PLAN COMMISSION PC #22-016
Westgate School Building Expansion
500 S Dwyer Ave
Round 2

P.C. Number 22-016
Project Name Westgate School Expansion
Project Location 500 S Dwyer Ave
Planning Department Contact Sam Hubbard

REVIEW ROUND 2

Project: Westgate School Building Expansion
500 S. Dwyer Ave.

503.2.1 Dimensions.

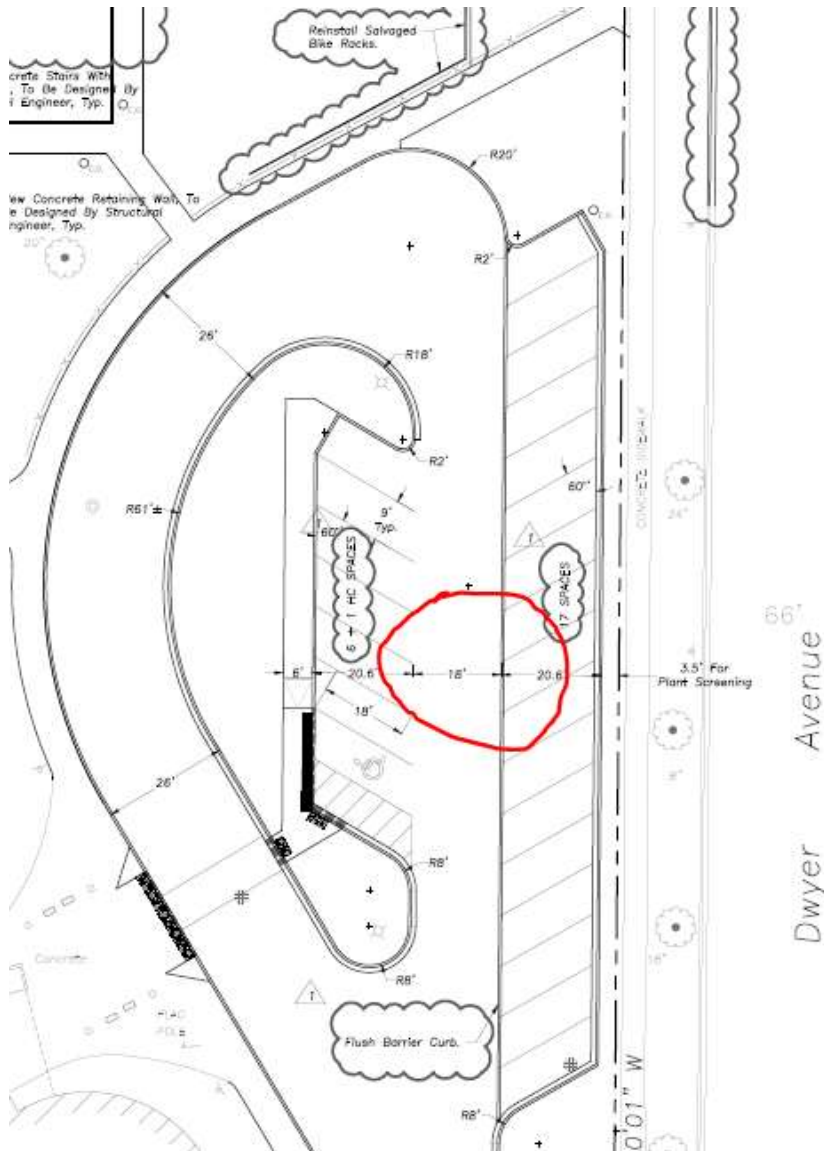
As previously noted in Fire Department revised comments emailed on 12-15-23, the Fire Department wants to keep the existing east drive access at Westgate School “as-is”. The proposed modification to the east access road does not meet the code requirements for a Fire Apparatus Access Road.

Fire apparatus access roads shall have an unobstructed width of not less than 20 feet (6096 mm), exclusive of shoulders.

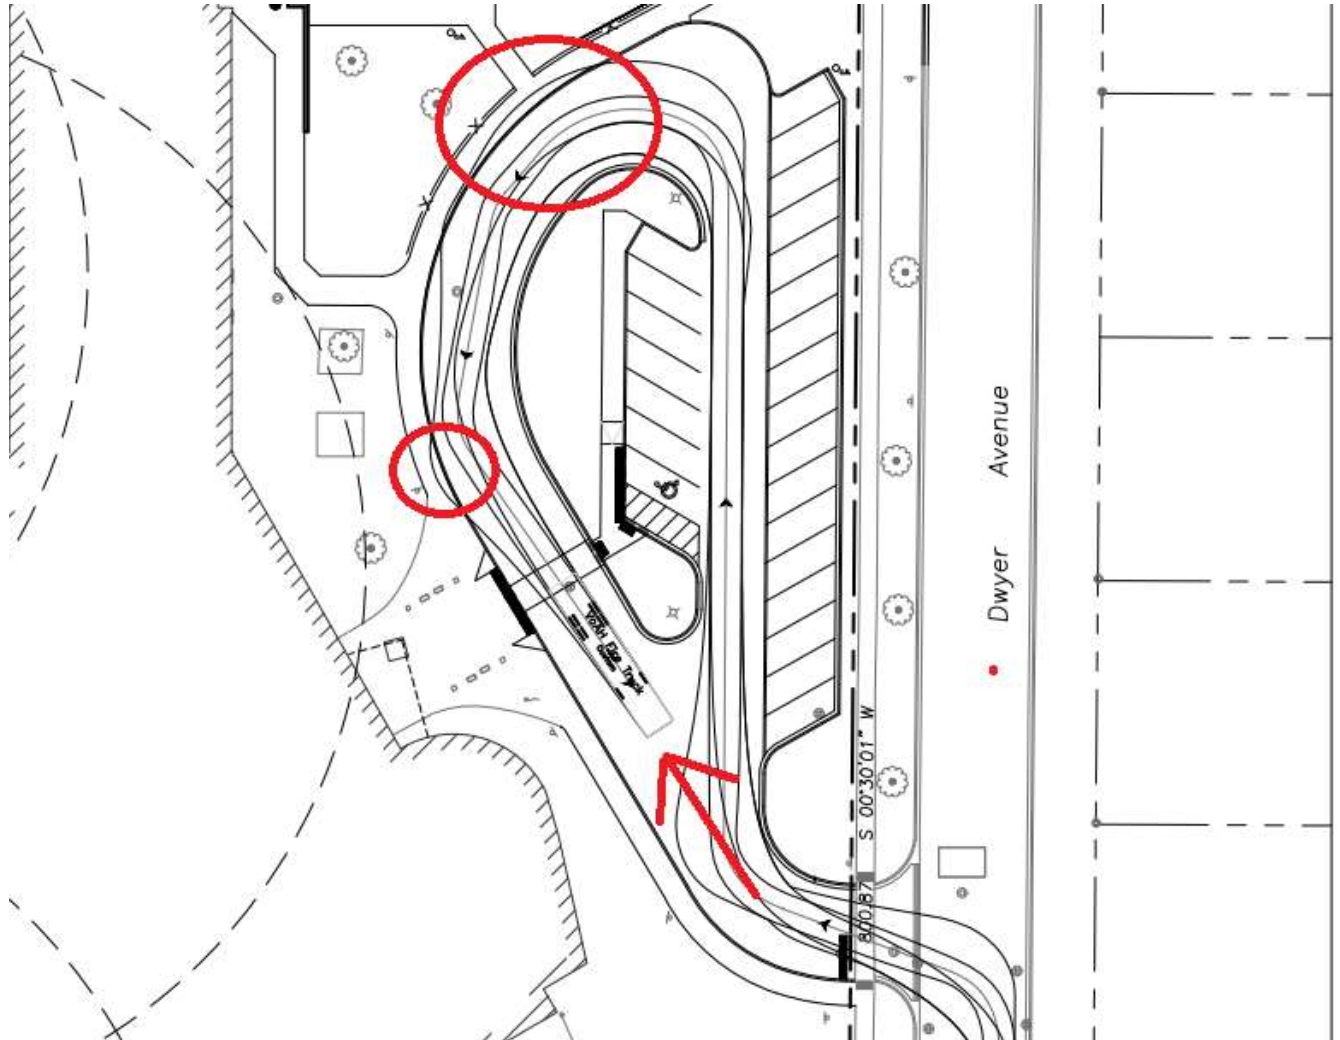
Also, the “auto-turn” diagram with the proposed changes to the east access has overhangs as noted below.
